## TECHNICAL MEMORANDUM

**FROM:** John Sigda, Ph.D. and Eileen Marcillo, INTERA Incorporated

**TO:** Rick Shean, Water Quality Hydrologist, Albuquerque Bernalillo County Water Utility Authority (ABCWUA)

**SUBJECT:** Review Findings for RCRA Facility Investigation Report Bulk Fuels Facility Release Solid Waste Management Unit ST-106/SS-111 dated January 2017

Figure 1  
LNAPL Presence in 2014  
ABCWUA

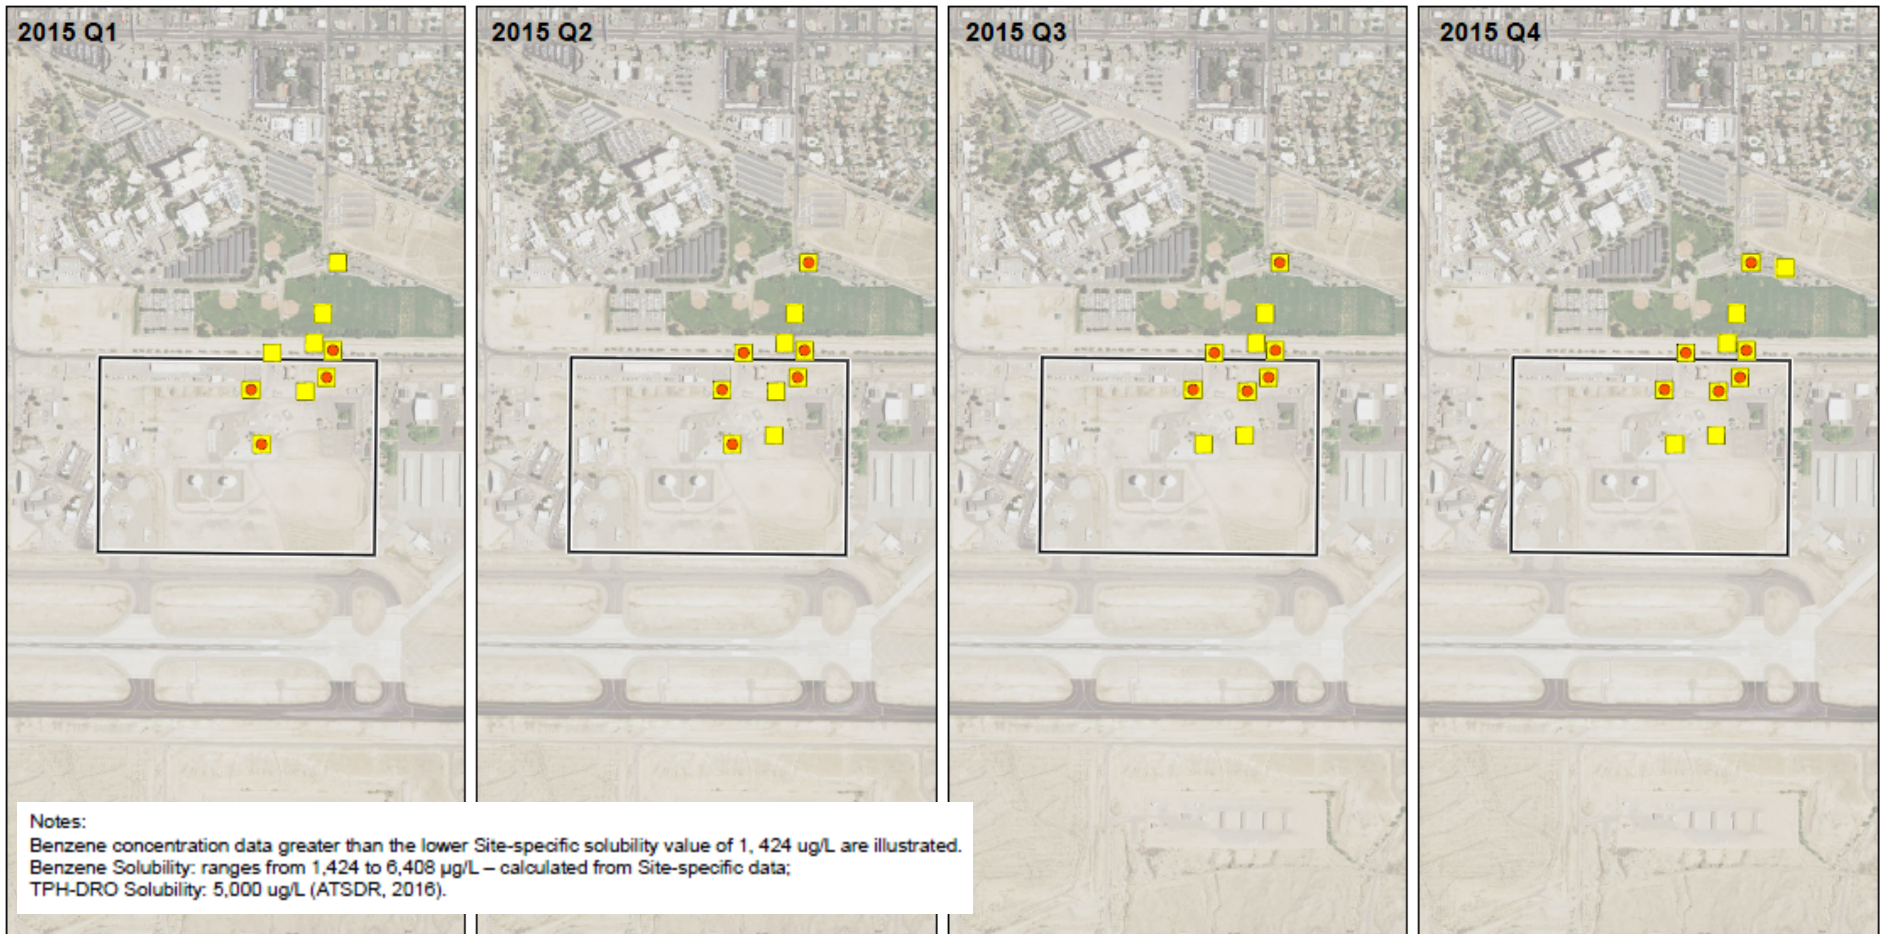
The RFI states that LNAPL has only been observed at one or two monitoring wells since 2012 (Figure 5-4). In fact, the RFI presents an incomplete picture of all the information about LNAPL extent, greatly underestimating its extent in the aquifer. **Figures 1 and 2** show that benzene and TPH-DRO concentrations exceeded their estimated effective solubility values at 12 locations in the fourth quarter of 2014 and at 11 locations in the fourth quarter of 2015. In comparison, RFI Figure 5-4 depicts LNAPL is present at two locations in the fourth quarter of 2014 and at one location in the fourth quarter of 2015. The RFI should be revised to discuss all indicators of LNAPL presence, including effective solubility for benzene, TPH-DRO, and other constituents.

Figure 3  
 Non-Degradation Mechanisms for  
 Concentration Changes at  
 KAFB-1065  
 ABCWUA

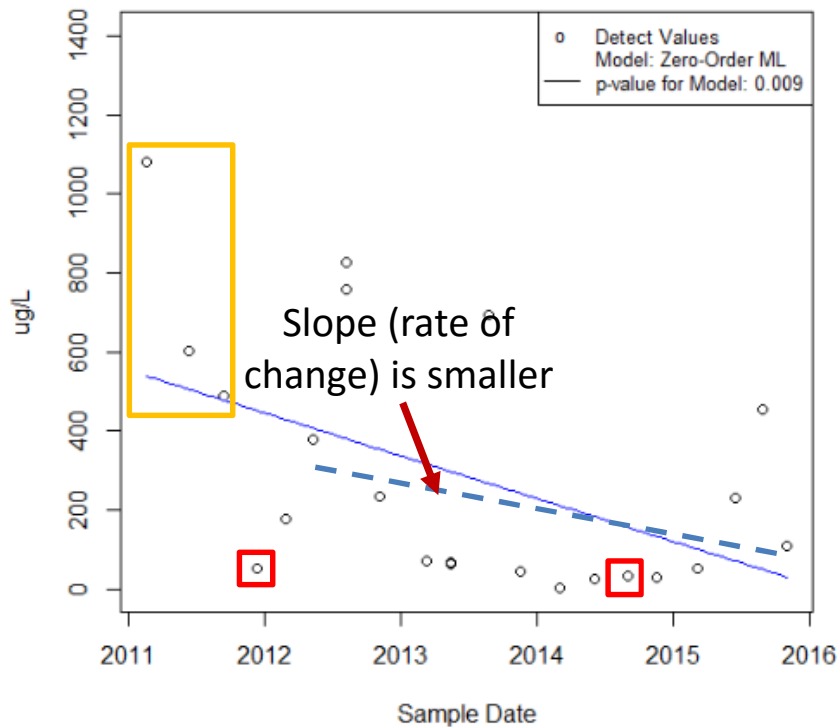
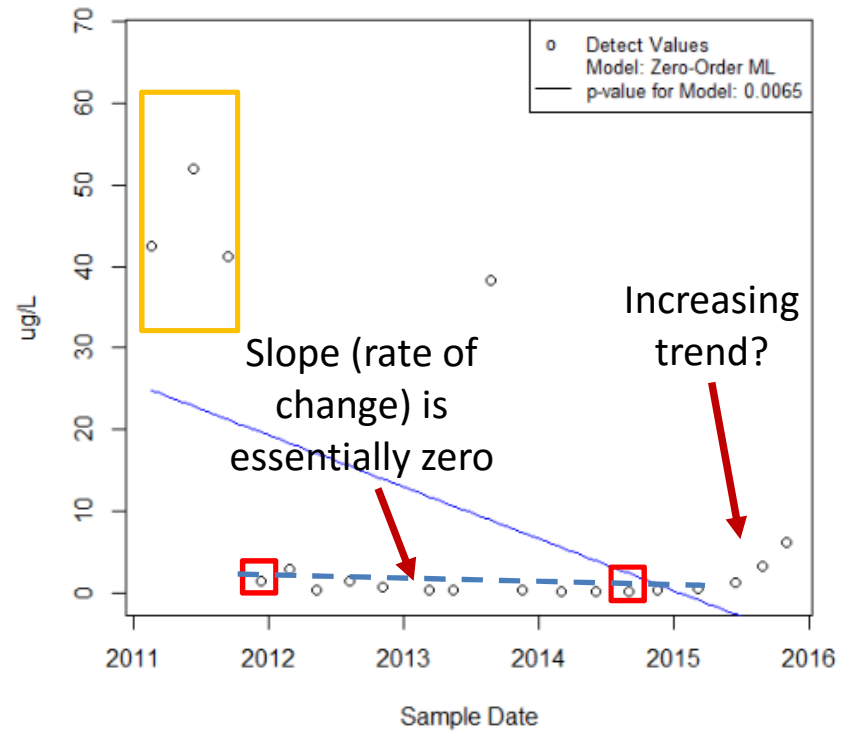
As shown in **Figures 3** through **7**, the RFI statistical analysis is applied to all data from the time period of interest, even when remediation was active, LNAPL was present, or the screen was submerged. Including measurements when LNAPL was present (either by measured thickness or effective solubility) is not appropriate or defensible when trying to estimate degradation rates or half-lives. These measurements and those taken when remediation was active or the screen is submerged should be removed from the statistical data set to create a corrected data set before estimating the degradation rate. **Figures 8** through **12** show examples of the data sets corrected for remediation and LNAPL presence. Examination of these figures shows that remediation and the presence of LNAPL are associated with high concentrations whereas submergence of the monitoring well screens is commonly associated with large decreases in measured EDB concentrations. The RFI's estimates of degradation rates and half-lives are invalid because other processes are changing concentrations. Appendix T and all related text should be removed from the RFI report until the analyses are carried out in a correct and scientifically defensible way.

- Degradation rate calculations should exclude data when remediation is active or LNAPL is present based on thickness or effective solubility
- Correct data sets show benzene concentration is increasing over time (as is LNAPL presence) and very slow decrease in EDB concentration

Figure 4  
Non-Degradation Mechanisms for  
Concentration Changes at  
KAFB-1066  
ABCWUA

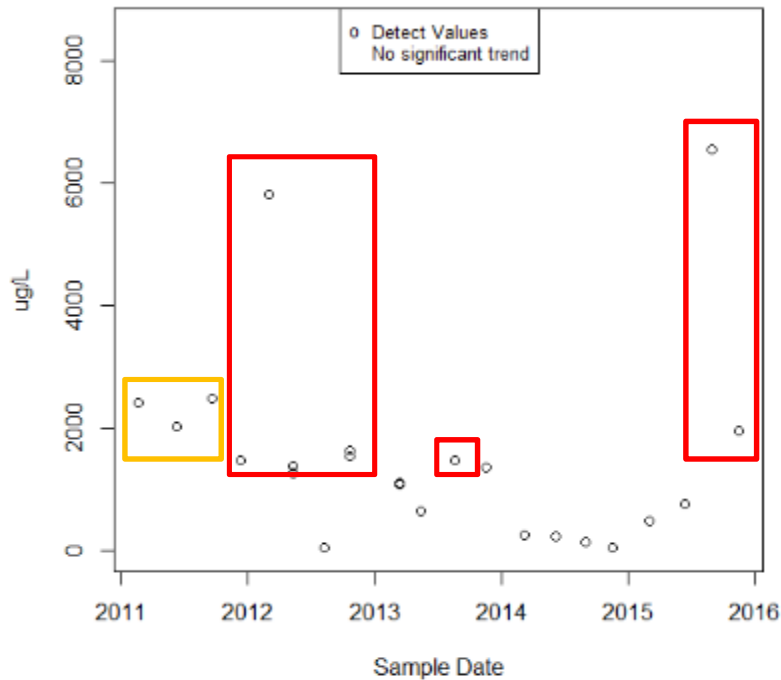
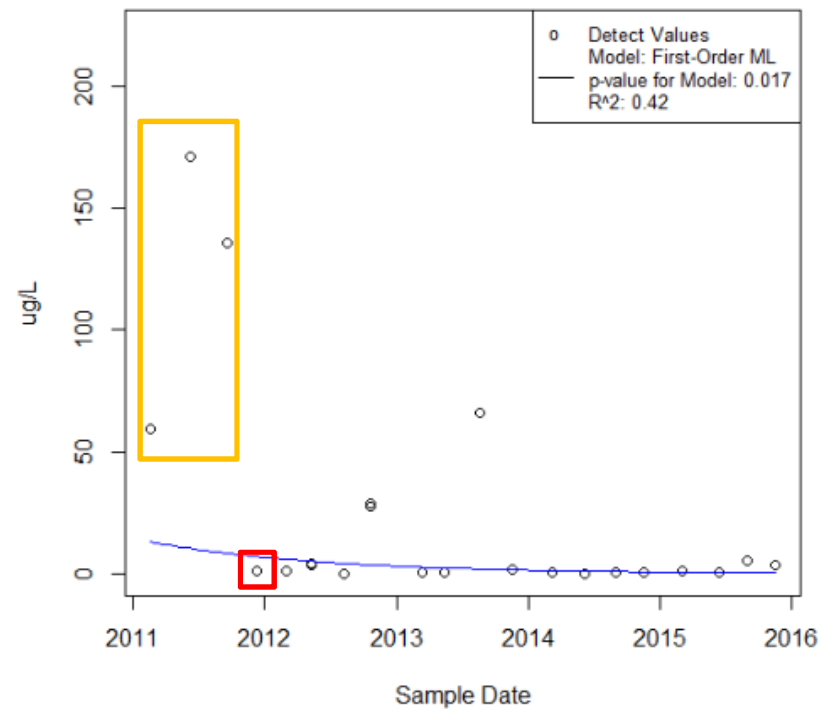
- Degradation rate calculations should exclude data taken when remediation is active or LNAPL is present based on thickness or effective solubility
- Correct data sets show benzene concentration is slowly decreasing and EDB concentration is unchanging until an increase during 2015

Figure 5  
Non-Degradation Mechanisms for  
Concentration Changes at  
KAFB-1068  
ABCWUA

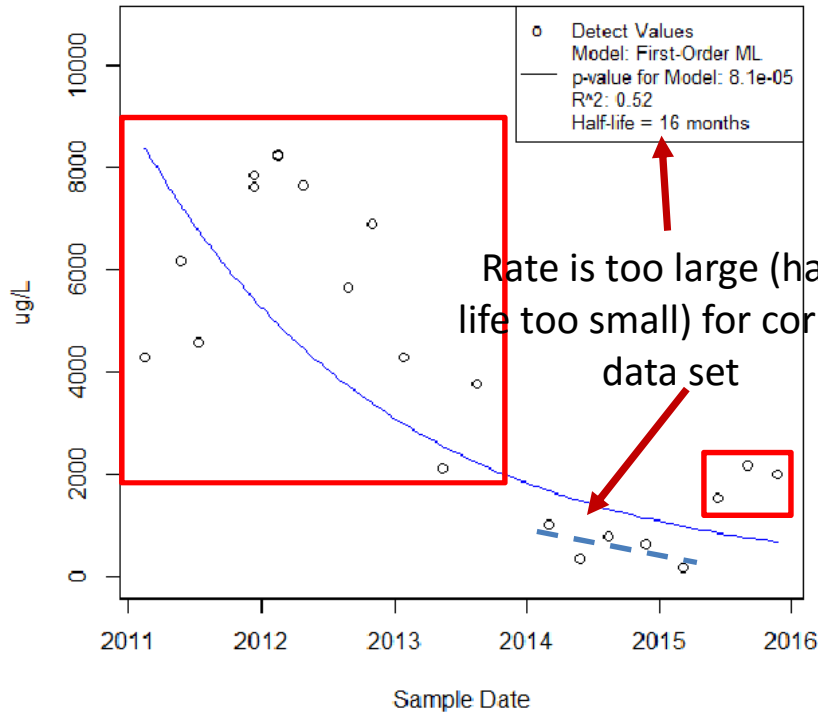
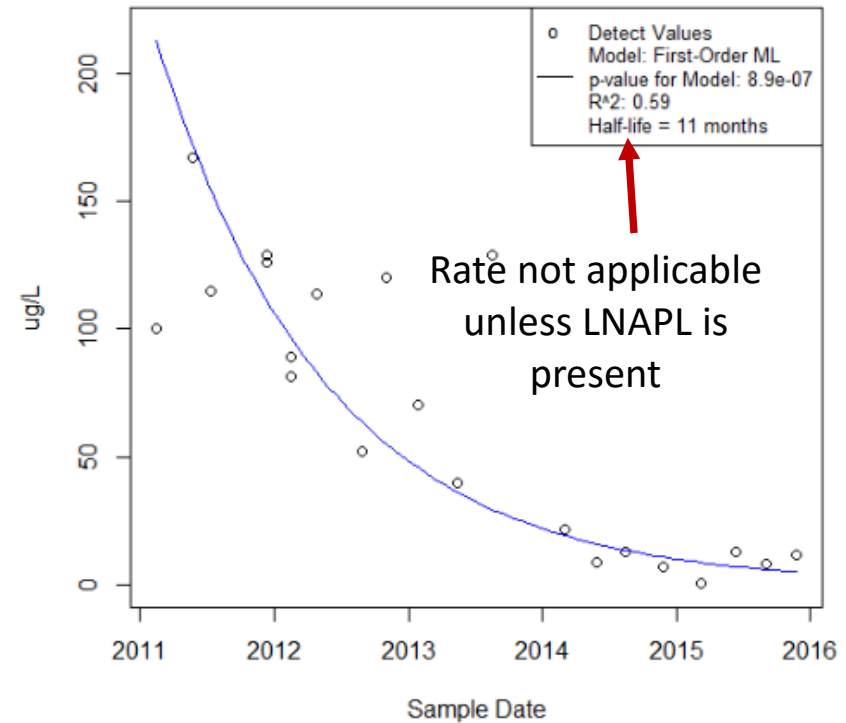
- After remediation ended, benzene concentrations show LNAPL is persistent, even in recent quarters
- LNAPL presence may cause EDB concentrations to always exceed MCL and to show minimal to negligible degradation

Rate is too large (half-life too small) for correct data set

Rate not applicable unless LNAPL is present

Figure 6  
Non-Degradation Mechanisms for  
Concentration Changes at  
KAFB-10610  
ABCWUA

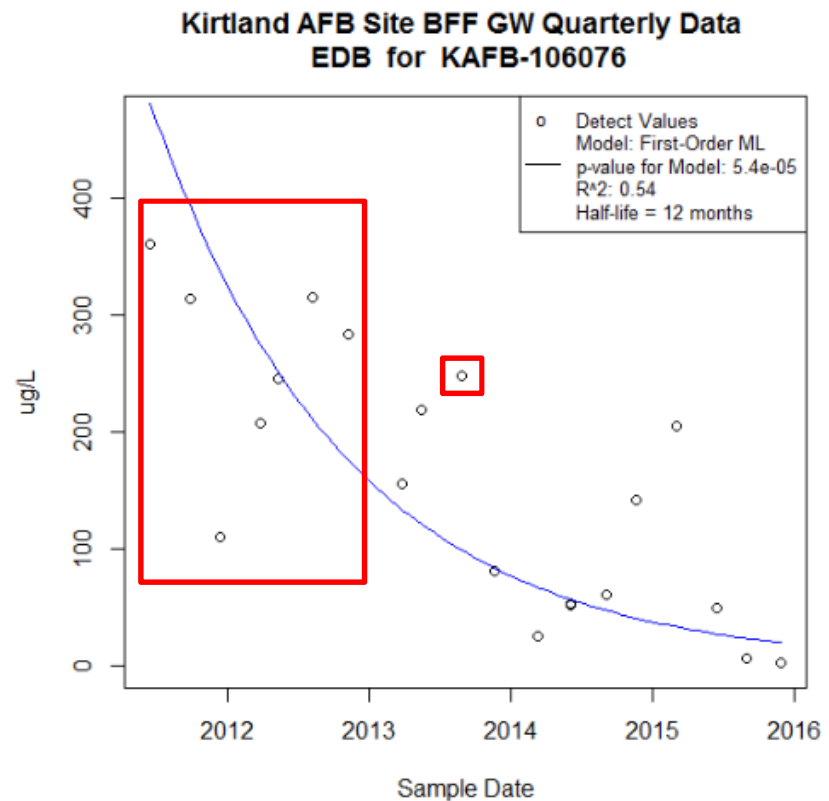
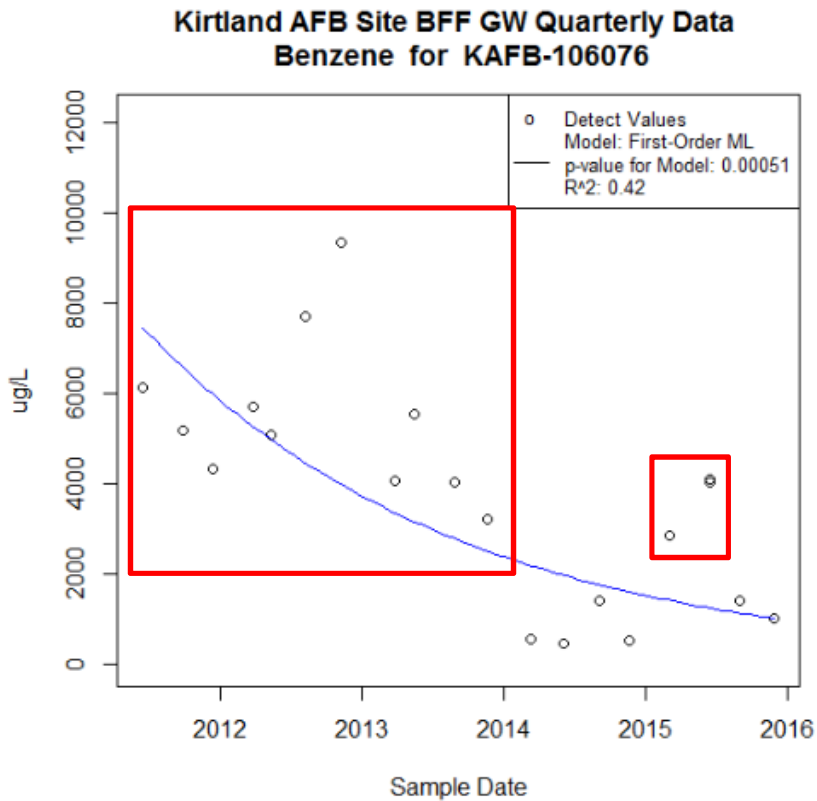
- 14 of 19 quarters of benzene measurements cannot be used to estimate degradation because LNAPL was present
- EDB degradation in LNAPL presence is not representative of degradation away from LNAPL

Figure 7  
Non-Degradation Mechanisms for  
Concentration Changes at  
KAFB-106076  
ABCWUA

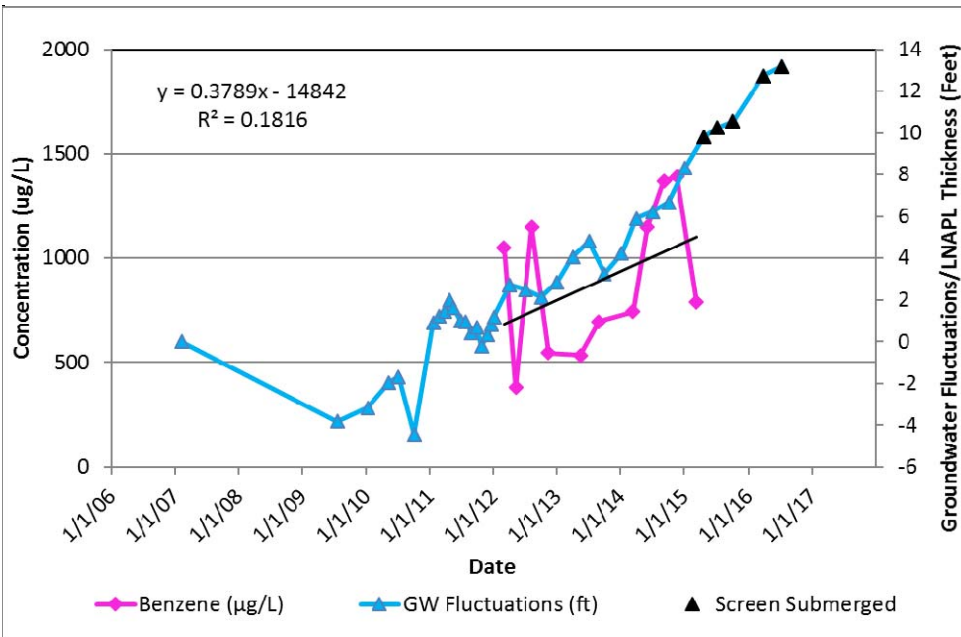
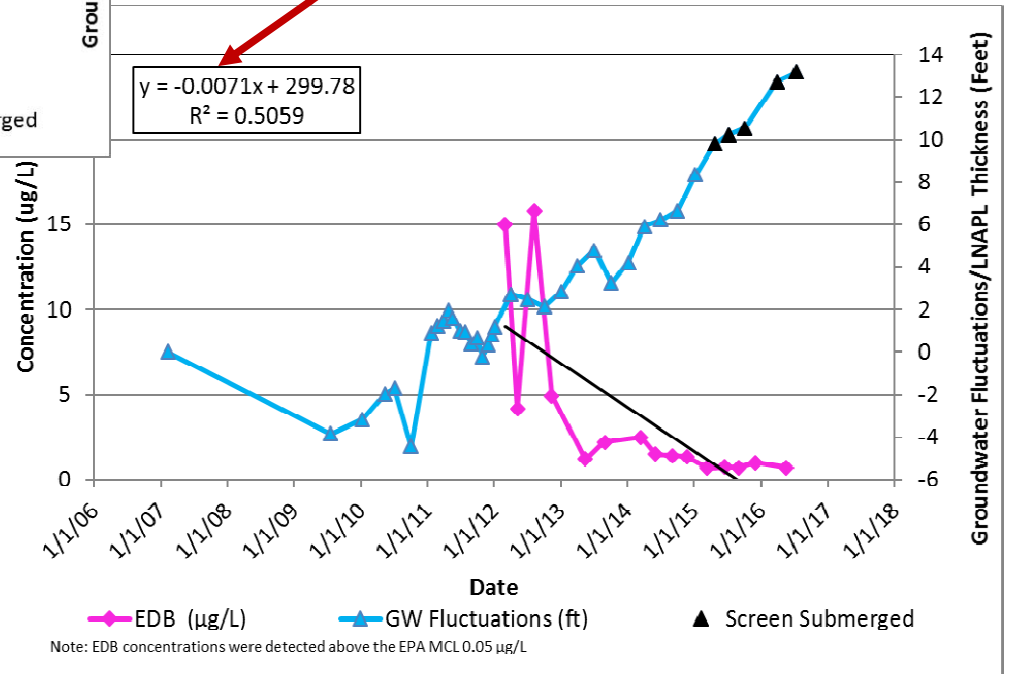
- LNAPL has been consistently present in 13 of 19 quarters of benzene measurements and 8 of the first 10 quarters of EDB measurements
- Cannot use measurements when LNAPL is present to estimate either EDB or benzene degradation

Figure 8  
Partially Corrected Data Set for  
Non-Degradation Mechanisms at  
KAFB-1065  
ABCWUA

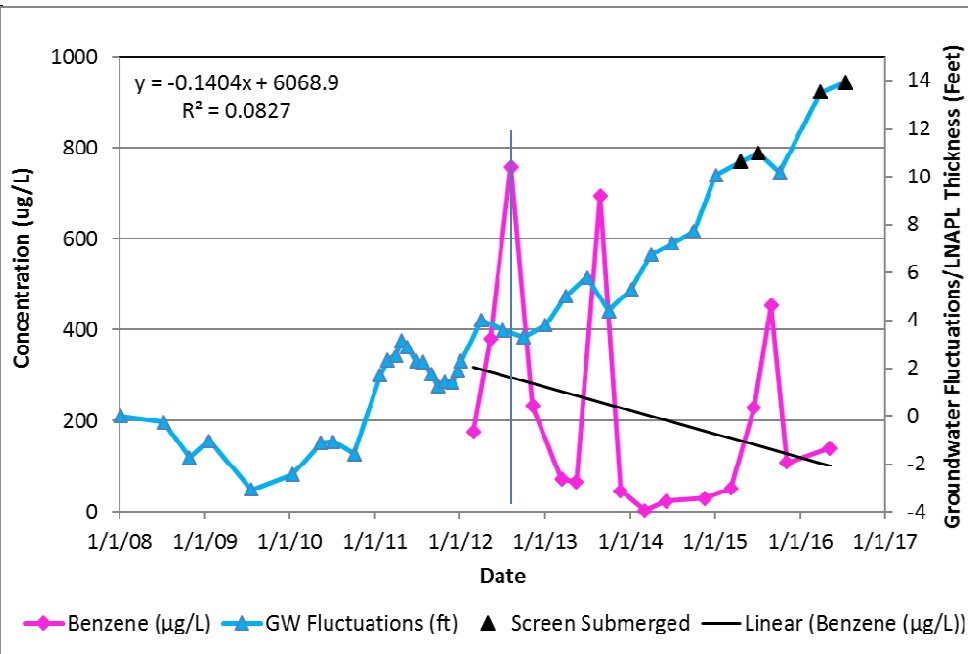
Slope (rate of change) is essentially zero

How much of the EDB concentration decrease from late 2012 to present was caused by the large increase (about 10 feet) in water level?

Figure 9  
Partially Corrected Data Set for  
Non-Degradation Mechanisms at  
KAFB-1066  
ABCWUA

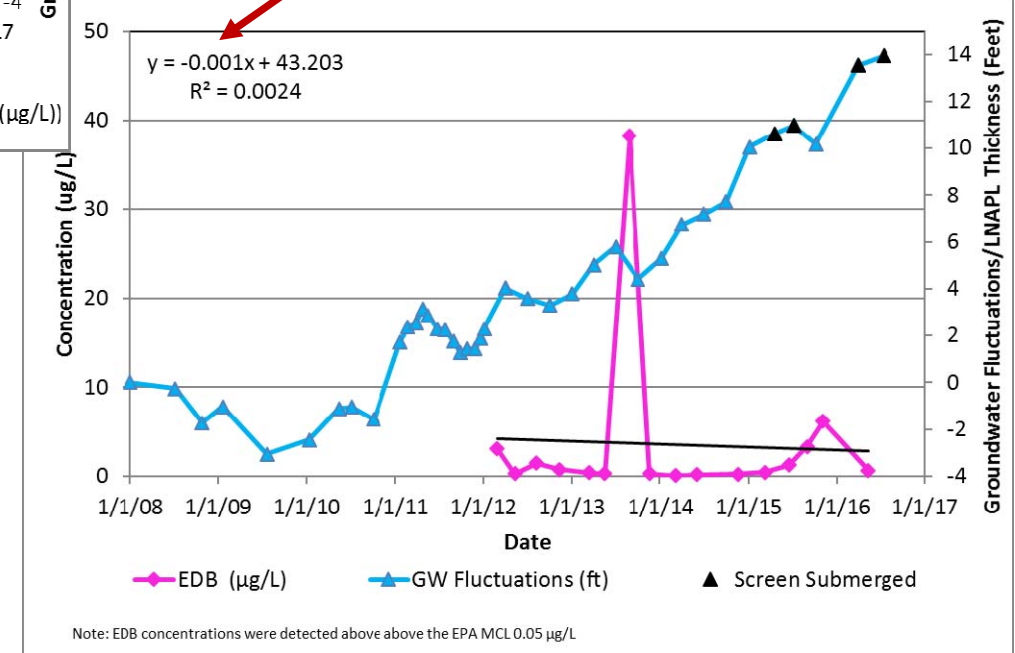
Slope (rate of change) is essentially zero

Note concentration spikes occur as or when groundwater level drops
